# PLAN CORRECTIONS REPORT (DRB21-0707)

<b>PLAN ADDRESS:</b>	W 424 W Rivo Alto Dr Miami Beach, FL 33139-1262	<b>PARCEL:</b>	0232330010330
<b>APPLICATION DATE:</b>	06/24/2021	<b>SQUARE FEET:</b>	7,110
<b>EXPIRATION DATE:</b>		<b>VALUATION:</b>	\$4,000,000.00
		<b>DESCRIPTION:</b>	THE CONSTRUCTION OF A NEW TWO STORY SINGLE FAMILY RESIDENCE WITH UNDERSTORY, THREE CAR GARAGE, DRIVEWAY AND POOL AND THE DEMOLITION OF AN EXISTING RESIDENCE

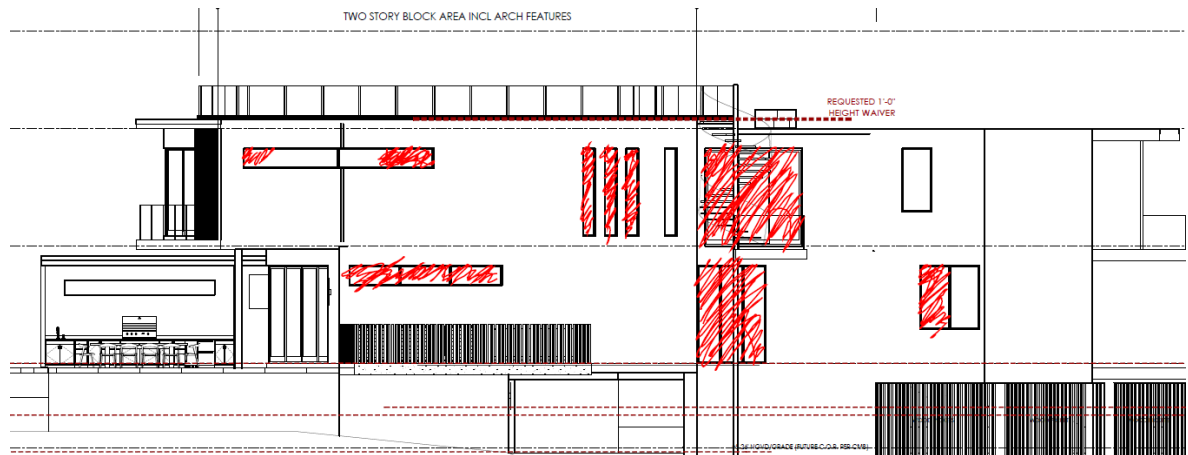
4. South Side elevation needs more interest and planar movement. **RESPONSE: THERE ARE NUMEROUS WINDOWS ADDED TO THE SIDE ELEVATIONS. THE WINDOWS NOTED IN RED BELOW HAVE BEEN ADDED. WE HAVE ADDED A LARGE TRANSOM ON THE FIRST LEVEL, FIXED WINDOWS FLOOR TO CEILING IN THE DINING ROOM. AN ADDITIONAL WINDOW ON THE FIRST LEVEL TO THE BEDROOM. IN ADDITION, WE HAVE ADDED THREE WINDOWS TO THE SECOND LEVEL, A SLIDING GLASS DOOR TO THE LOFT AND EXTENDED THE TRANSOM IN THE MAIN CLOSET.**
